Brighton Wastewater Treatment System Upgrades

ADDENDUM NO. 004

June 2, 2025

Item No. 48 Are hooks required in base slabs at expansion joints? Section 2/S424 shows hook and there are multiple other sections that do show straight bars. See below details.

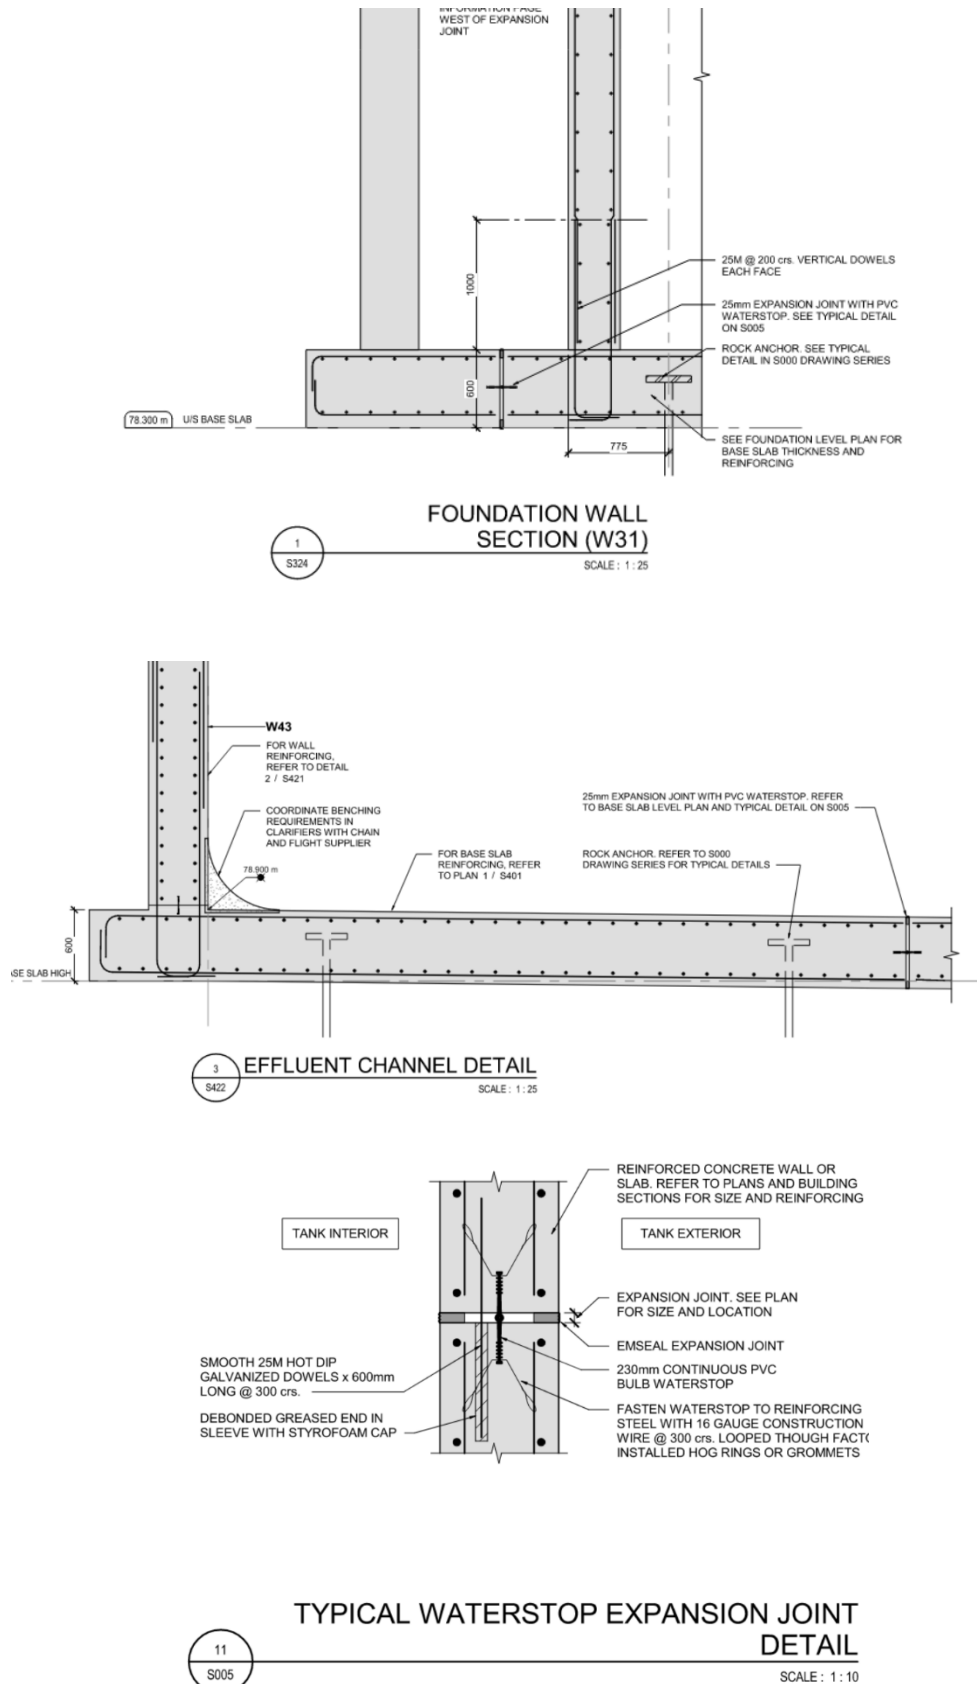
2/S424 shows hooks on the base slab bars at expansion joints.

Section 1/S324, 3/S422, and 11/S005 shows straight bars

- 48.1 Straight bars can be provided in base slabs where bars terminate at locations of expansion joints.
